To:	Karyn Lewis, Project Manager Lupin Project Mandalay Resources Corporation, Suite 330, 76 Richmond Street Toronto, ON M5C 1P1	From:	Alvin Tong, P.Eng. Stantec Consulting Ltd., 1100 – 111 Dunsmuir Street Vancouver, BC V6B 6A3
File:	Lupin Gold Project - 129500081	Date:	June 8, 2020

Reference: 2 AM-LUP2032 Technical Memorandum on Additional Geotechnical Details on TCA Dam K and Dam M Cross Sections

Title
CELL 5 CLOSURE

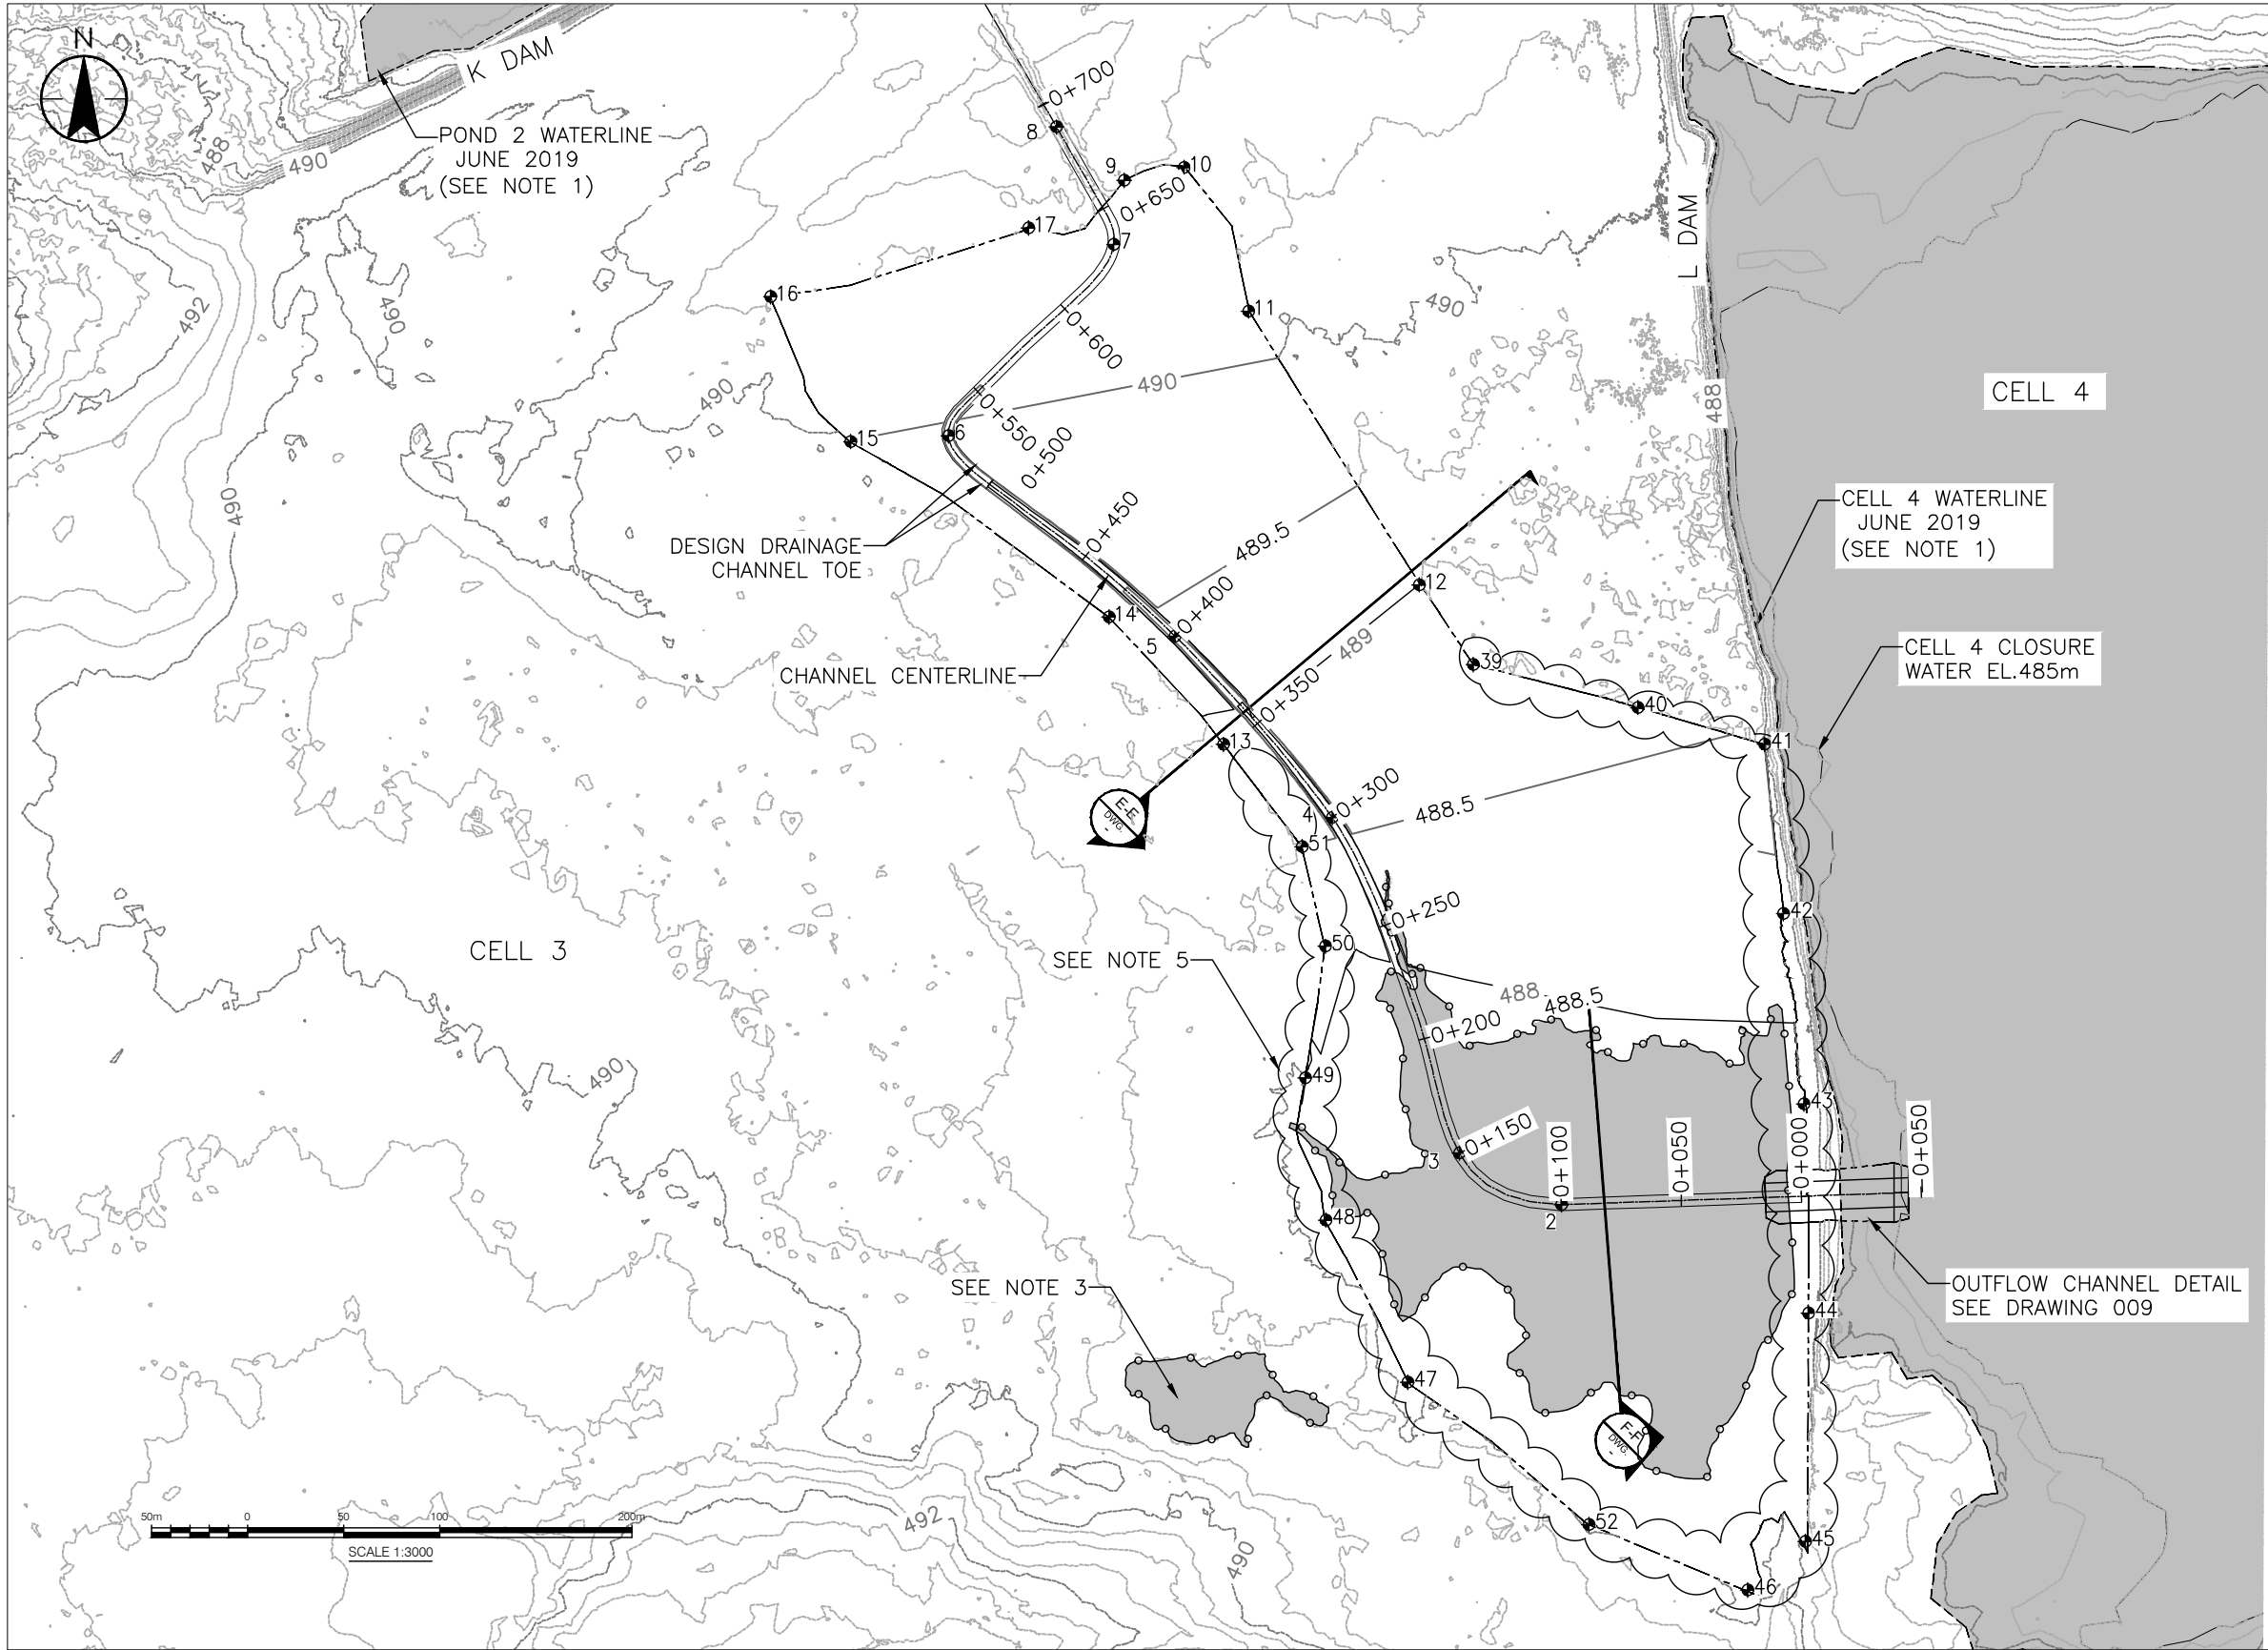
- a. Magnified image that clearly identifies the materials used for the re-sloping, the distance that the re-sloping materials will extend from the crest of these Dams (including a break line with minimums and maximums noted), and the distances to the closure water mark;*
- b. Perpendicular/longitudinal cross section of the outflow structures for Cell 5 and Cell 3, with invert elevations from the cover to the ponds, and a note to clarify the storm return period that will be used for designing the features.*

Please see attached detailed design drawings for the Tailings Containment Area (TCA) Cell 5 and Cell 3 outflow structures. These detailed design drawings include the requested cross sections. To clarify, as it is not shown in Drawing 005 for Cell 5 as it is shown in Drawing 009 for Cell 3, the storm return period used to design the design features in both cells is the 1-in-100-year, 24-hour storm event.
